STATE OF CONNECTICUT CONNECTICUT SITING COUNCIL

IN RE:	:	
	:	
A PETITION FOR A DECLARATORY	:	PETITION NO. 1425
RULING THAT A CERTIFICATE OF	:	
ENVIRONMENTAL COMPATIBILITY AND	:	
PUBLIC NEED IS NOT REQUIRED FOR THE	:	
CONSTRUCTION, OPERATION AND	:	
MAINTENANCE OF A 1.9 MWAC SOLAR	:	
PHOTOVOLTAIC PROJECT AT 360	:	
GAYLORD MOUNTAIN ROAD IN HAMDEN,	:	
CONNECTICUT	:	DECEMBER 30, 2020

LATE-FILED EXHIBITS RESPONSES OF GAYLORD MOUNTAIN SOLAR PROJECT 2019 LLC

1 **SLOPE EXHIBIT** EXH-1 **SCALE : 1" = 80'-0"**

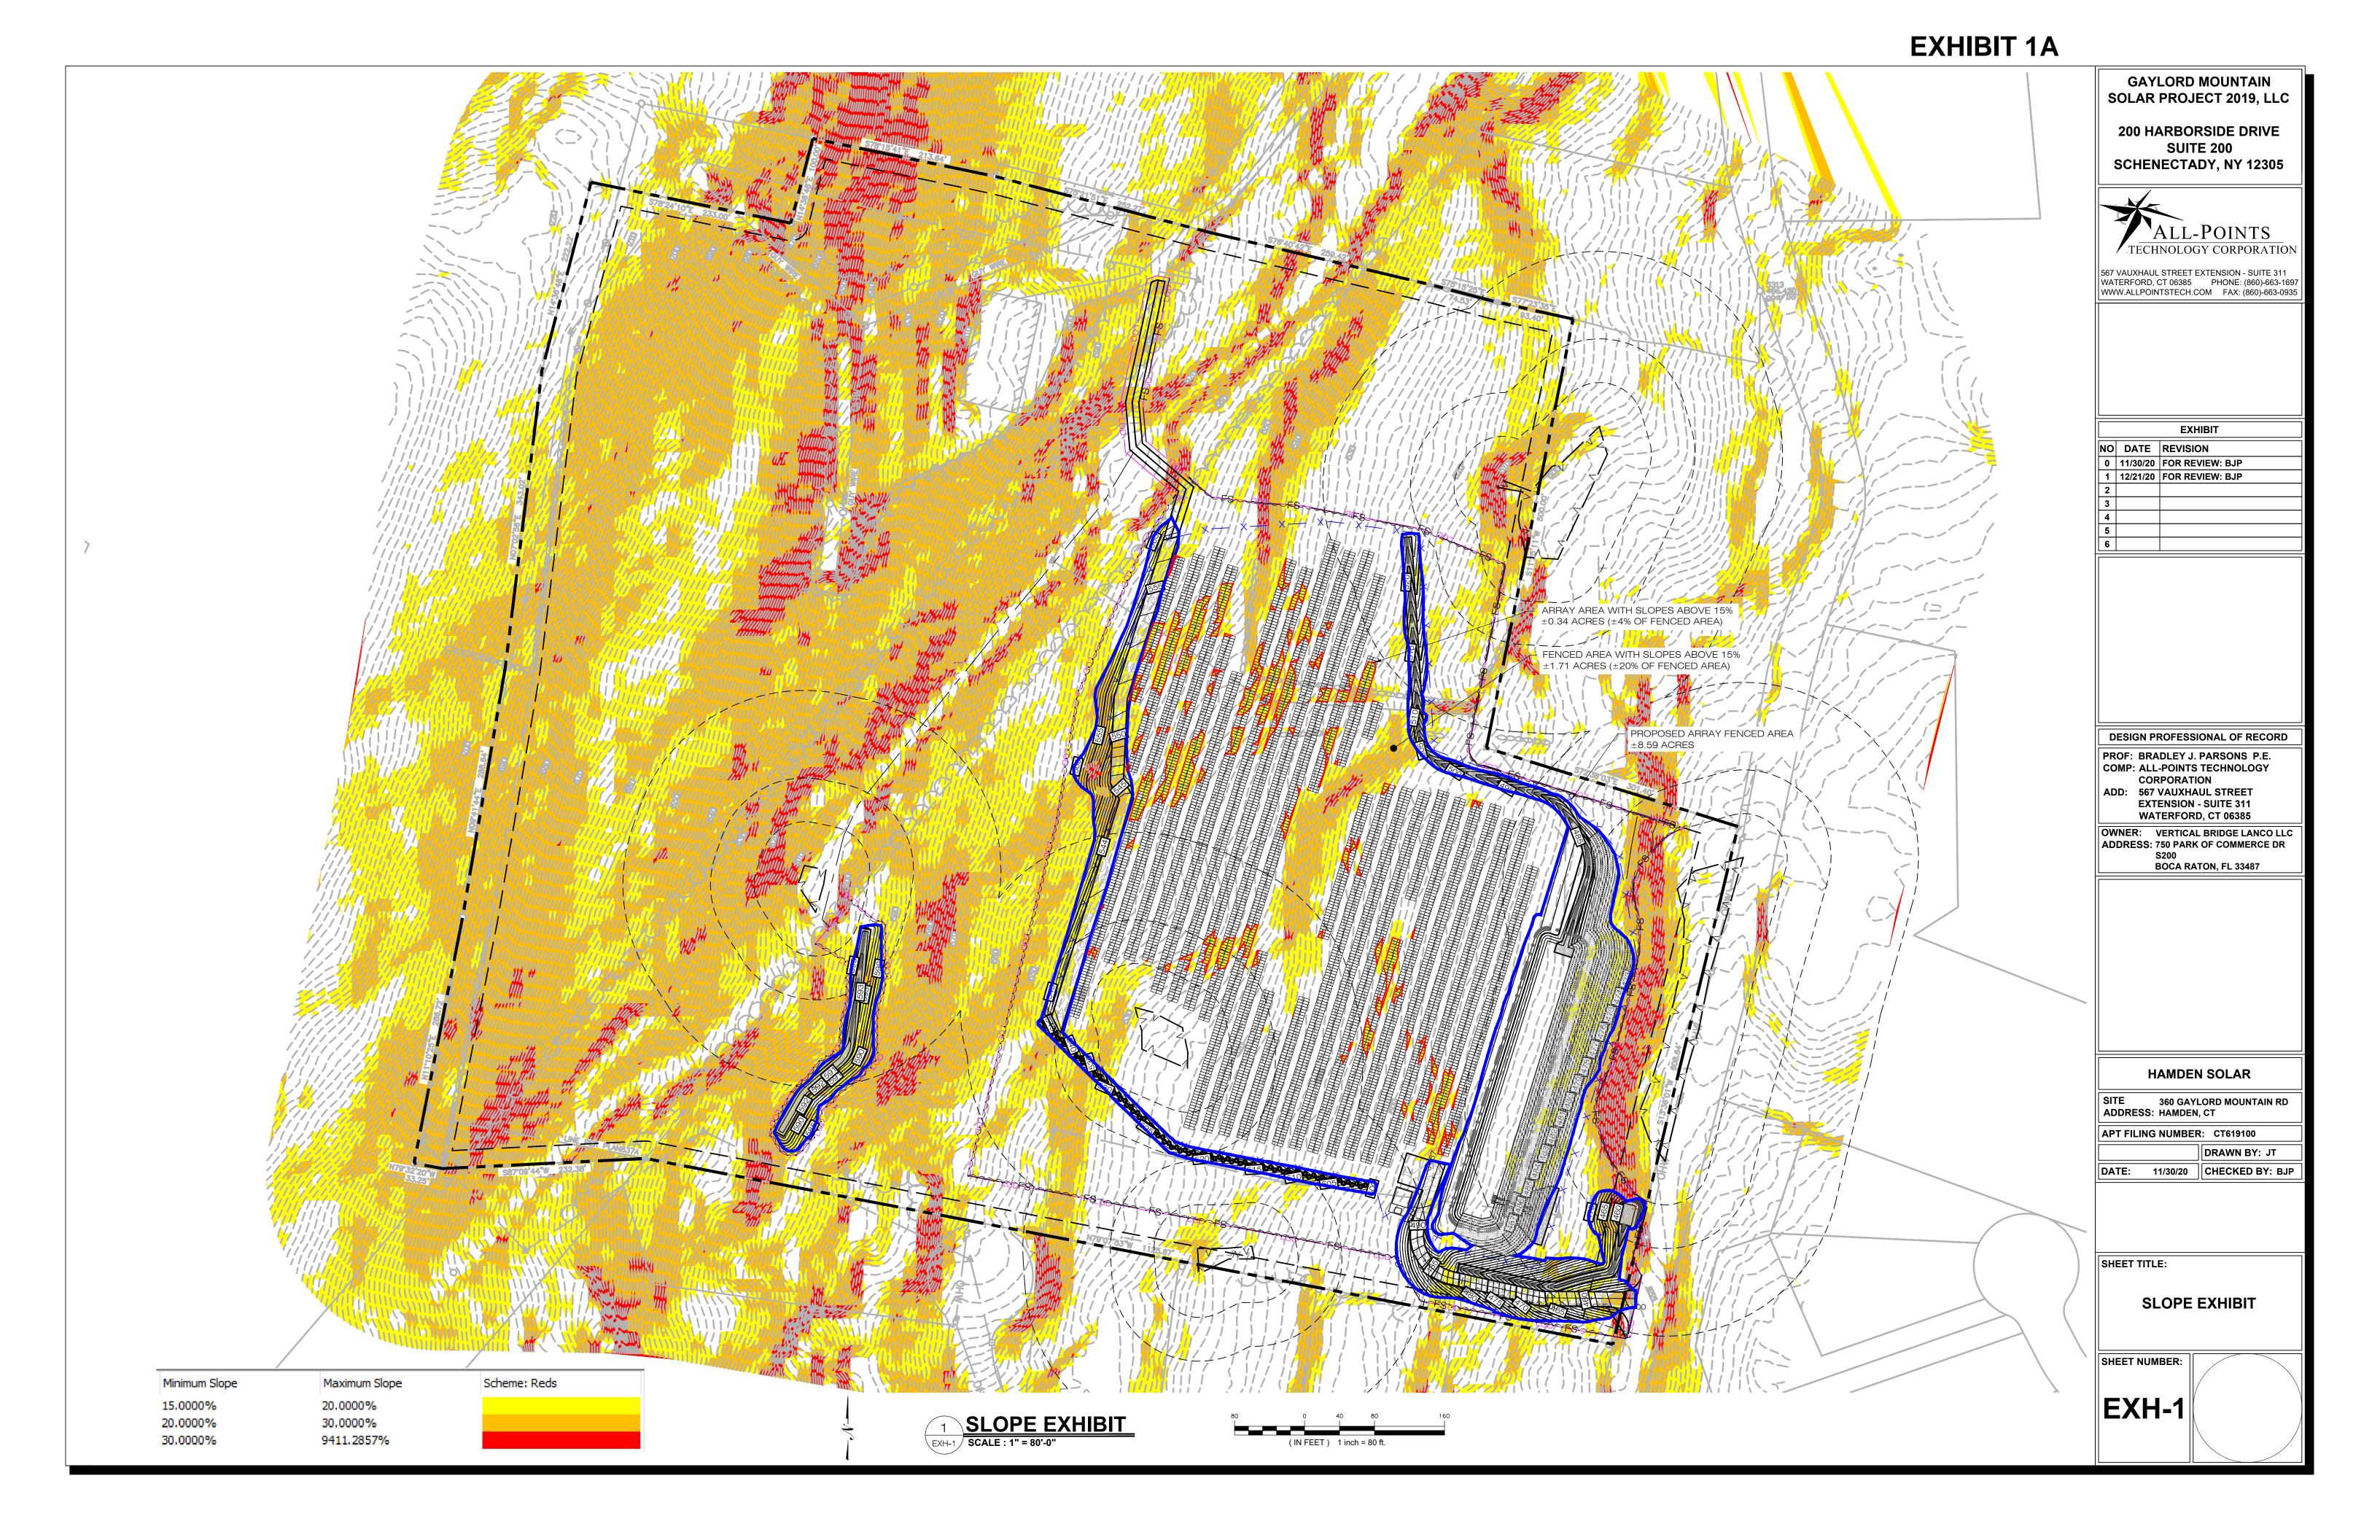
Information regarding the depth of residential wells in the area around the Gaylord Solar Facility location was requested from the Quinnipiack Valley Health District pursuant to the State's Freedom of Information Act. Unfortunately, due to restrictions related to the COVID 19 on Health District operations, it is unclear whether the well depth information will be provided prior to the Council's January 7, 2021 evidentiary hearing. That said, according to the Petitioner's geotechnical engineers, Down to Earth Consulting, LLC, residential drinking water wells in the area near the Gaylord Solar Facility likely will reach depths of more than 100 feet. (b) Revise the December 8, 2020 Late File Site Plan - Sheet EXH –1A to include the following: • the same slope information as provided on Late File Site Plan - Sheet CP-2; and • areas of site grading.

Attached to these Late File responses are two maps. The first map, labeled Exhibit 1A, is the December 8, 2020 Late File Site Plan – Sheet EXH -1A (Exhibit 2) revised to include the additional slope information requested by the Council. Also included on this plan are the areas where site grading will occur. These areas are outlined in blue. Site grading will be limited to the area near the proposed level spreader to the southwest of the solar array, the temporary construction access driveway along the west side of the solar array, the landscape berm along the south side of the solar array, the stormwater detention basin and rip rap drainage swale along the east side of the solar array, and the permanent site access drive and swale to the southeast of the solar array.

The second map, labeled <u>Exhibit 1B</u>, contains the same information provided in <u>Exhibit</u> <u>1A</u>, overlaid with the early concept plan layout from March of 2020 shown as Exhibit 3 of the Petitioner's December 8, 2020 Late File Exhibit responses. The overlaid solar array layout shows the panels oriented to face due south and shows panels located on some of the steeper slopes on the Property including, but not limited to, the area to the west of the temporary construction access drive.
